Access Compliance Report

Public Rights-of-Way

Intersection ID: 12704	Main Street: E_5TH_ST	Cross Street: N_DAVIDSON_ST	Location: N
ADA ID: DA886ECE1D6B	Ramp Type: PerpDiag	Initial Pass/Fail: Fail	Overall Compliance: No
		Severity Score: 25

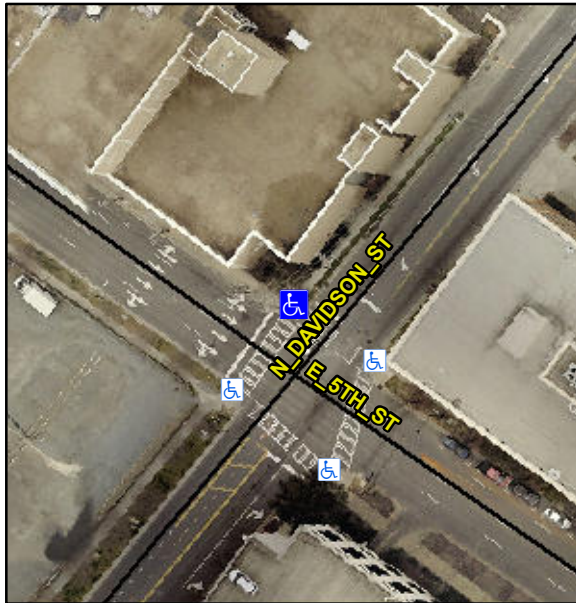
Not Found, R304.5.3

Compliance	Description	Data	Compliance	Description	Data
N/A	Ramp Length (in)	89.0	Yes	Ramp Slope (%)	7.6
Yes	Ramp Width (in)	48.0	No	Ramp XSlope (%)	7.0
N/A	Flare Type LT	N/A	N/A	Flare Type RT	N/A
N/A	Flare Slope LT (%)	N/A	N/A	Flare Slope RT (%)	N/A
N/A	Flare Traversable LT?	N/A	N/A	Flare Traversable RT?	N/A
N/A	Landing Length (in)	N/A	N/A	DWS Provided?	N/A
N/A	Landing Width (in)	N/A	N/A	DWS Contrast?	N/A
N/A	Landing Slope (%)	N/A	N/A	DWS Length (in)	N/A
N/A	Landing X Slope (%)	N/A	N/A	DWS Full Width?	N/A
N/A	Landing Curb? (Y/N)	N/A	N/A	DWS Offset (in)	N/A
N/A	Shared Landing?	N/A			
N/A	Gutter Ponding?	N/A	N/A	Gutter Slope (%)	N/A
N/A	Gutter Lip Ht (in)	N/A	N/A	Gutter X Slope (%)	N/A
N/A	Painted X Walk1?	Yes	N/A	Painted X Walk2?	Yes
	X Walk 1 Direction	To SW		X Walk 2 Direction	To SE
N/A	X Walk 1 Width (in)	104.0	N/A	X Walk 2 Width (in)	104.0
	X Walk 1 Slope (%)	9.4		X Walk 2 Slope (%)	0.2
	X Walk 1 X Slope (%)	1.0		X Walk 2 X Slope (%)	5.4

N/A	Ramp inside XWalk1?	Yes	N/A	Ramp inside XWalk2?	Yes
	Road Slope (%)	4.2	N/A	Clear Space?	N/A
	Road X Slope (%)	3.9	N/A	Clear Space to XWalk (in)	N/A
N/A	Any Obstructions?	N/A	N/A	Storm Grate/Utility Hazard?	N/A
	Obstruction Type			Storm Grate/Utility Type	
		N/A			N/A
		Yes		Surface Condition? (G/P)	Good

Remove & Replace Curb Ramp With Two New Directional Ramps or Equivalent.
